TECHNICAL MEMORANDUM

Project	J003038 198-222 Dominion Road & 113-117 Valley Road, Mt Eden
Subject	Section 92 Response
From:	Josh Brajkovic, Principal Consultant
To:	Gerard Thompson, Barker & Associates
Date	1 October 2024

Table 1: Section 92 Requests and Responses

Figure 1: Visibility at driveway

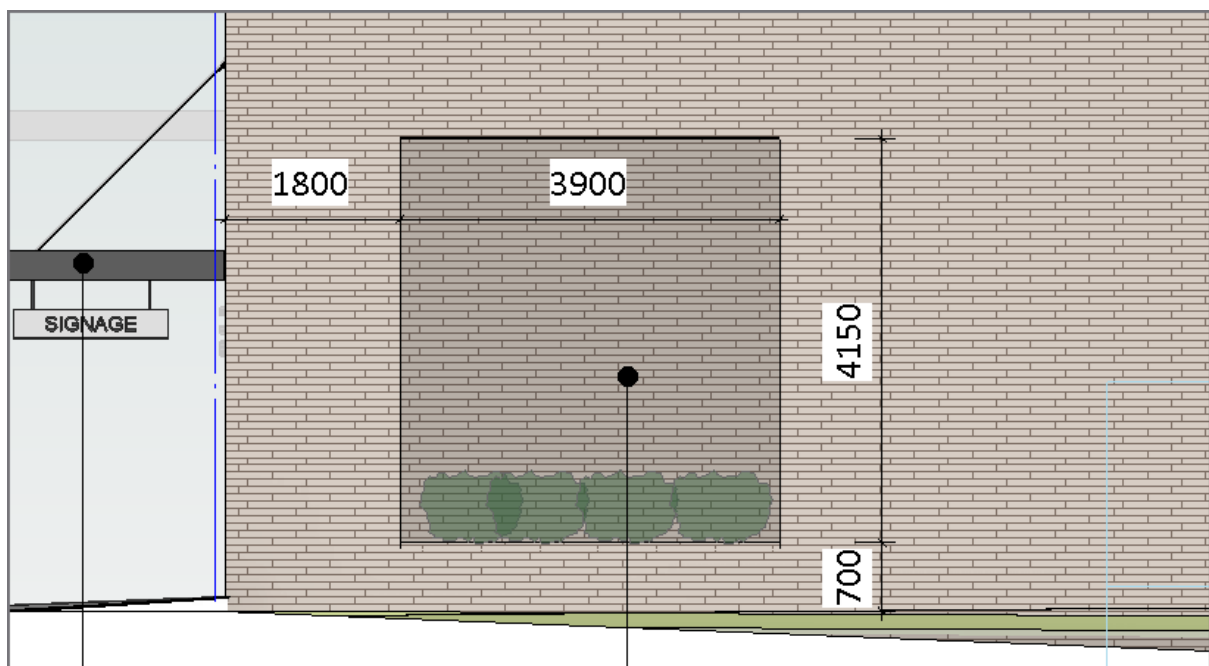
access Woolworths. If any potential adverse effects are identified, please provide an assessment on how such adverse effects will be avoided, remedied, or mitigated.	connection will use the signalised pedestrian crossing to access Woolworths. Residents using the Valley Road connection will also use this signalised crossing, which is located approximately 35m to the west. This is considered a reasonable additional distance for pedestrians to travel to access Woolworths. As such, the proposed pedestrian connections are considered acceptable.
5	<p>Section 4.5 notes that an access gate is setback 10.2m from the property boundary “to ensure queued vehicles are contained on-site and not extend over the pedestrian footpaths or onto the arterial roads.”. Upon review of the architecture plans, AT notes that columns are proposed on either side of the vehicle crossing, as shown in Figure 1 below. Given the scale of the development and the relatively high pedestrian traffic on Valley Road, AT considers that the proposed columns could potentially impede the visibility of exiting vehicles.</p> <p>Further, AT considers that the 10.2m setback could potentially allow exiting vehicles to pick up speed once the gate opens, resulting in pedestrian safety-related adverse effects.</p> <p>To ensure pedestrian safety at the vehicle crossing in accordance with E27.8.2 (11), please provide an assessment on how pedestrian safety and intervisibility will be ensured at the crossing and how any potential adverse effects could be avoided, remedied, or mitigated.</p>	<p>Given the gate location, vehicle speeds on the access will be low. Vehicles exiting the site stopped at the gate only have 10m to travel before having to stop again before the intersection. As such, we do not consider vehicles will be able to accelerate to faster than 10km/h. This is considered an appropriate vehicle speed on a private vehicle access.</p> <p>For exiting vehicles, full visibility is available to the footpath to the drivers right hand side, given the two-way access. To the drivers left, a large opening in the wall is provided to enable visibility between vehicles and pedestrians. The opening is shown in Figure 1 and Figure 2 below. As such, the proposed vehicle access design is considered acceptable.</p>

Revision notes:			Drawn by:		Project:		Date:				Figure: S2	
Rev:	Date:	Notes:	JB		Dominion Rd & Valley Rd		23/09/2024					
			Client:		Residential Development		Scale @ A3:					
			Drawing Title:		Valley Road Access Road Modifications		1:200					
							Revision:					
							A

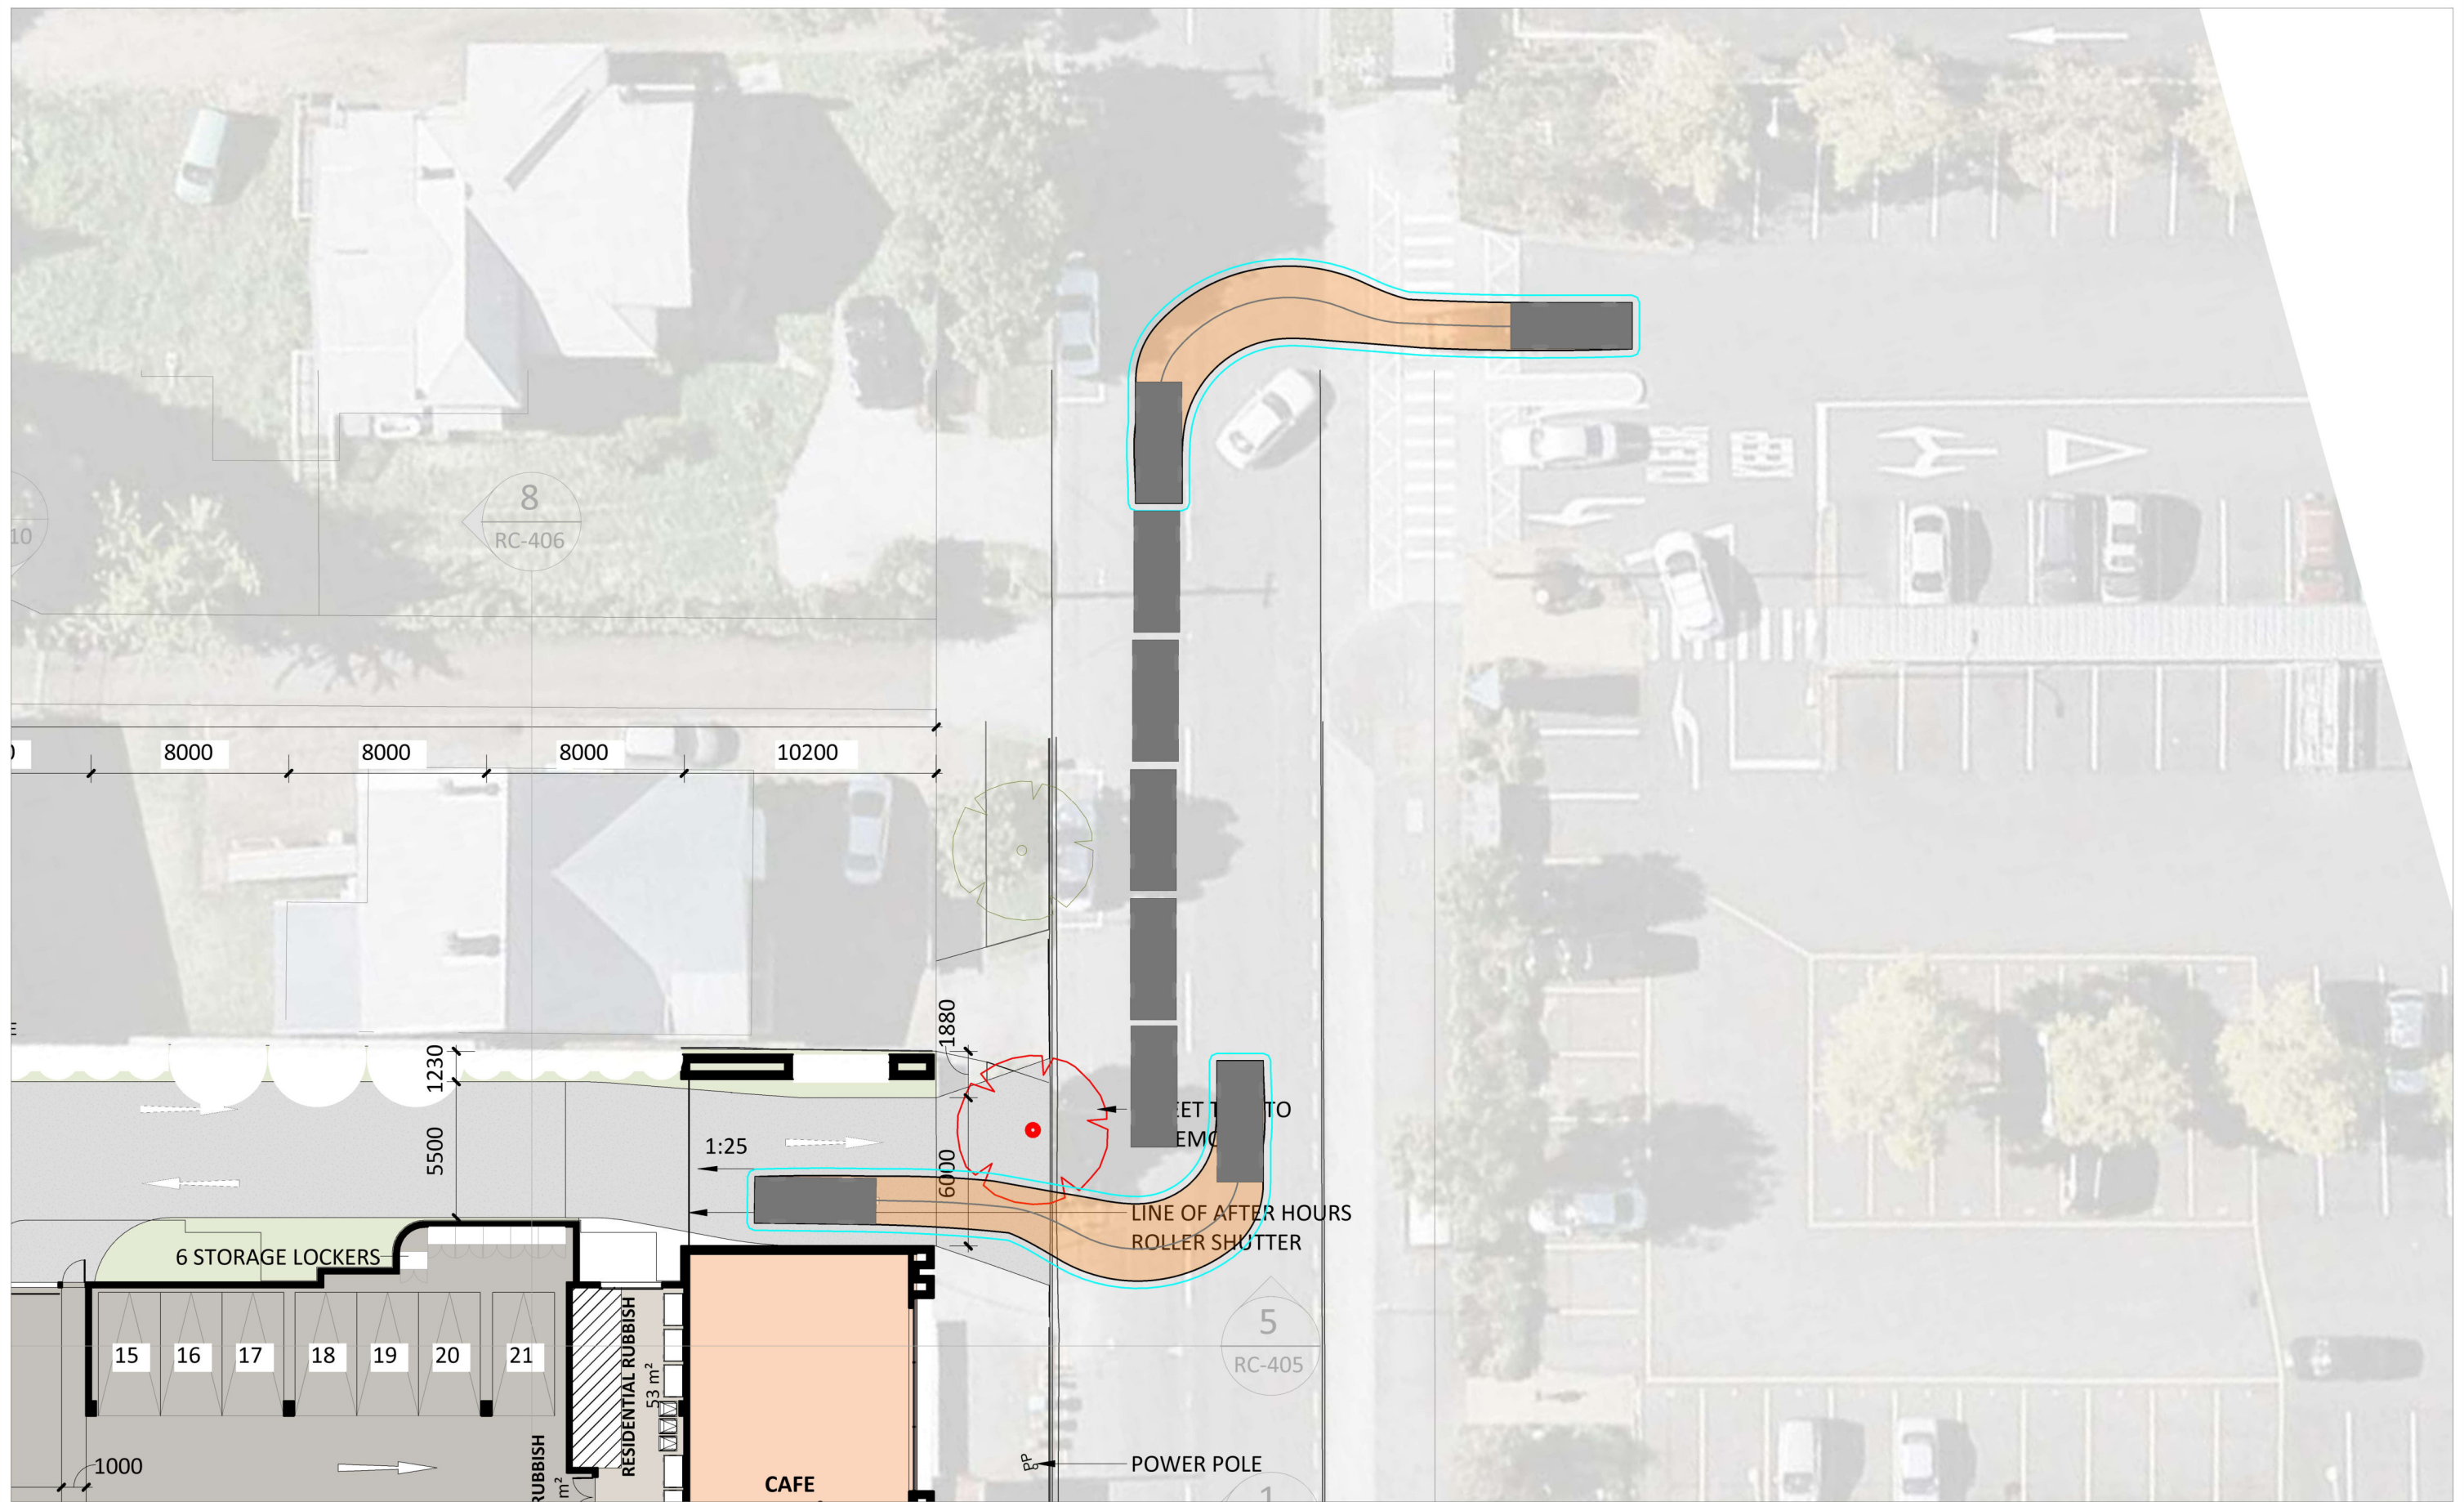
6	<p>Section 5.2 of the TIA notes that “on-street parking removal will be required to establish the new vehicle crossing. The closure of the existing vehicle crossings and reinstatement to kerb and footpath will result in the availability of additional on-street parking space being created, if desired by AT.”</p> <p>The applicant is requested to provide an updated plan indicating the amendments proposed to the road reserve (including but not limited to the NSAATs, the extent to which the existing on-street parking spaces will be removed and the location where the parking spaces could potentially be reinstated).</p>	Figure S2 attached shows the proposed changes to the Valley Road frontage.
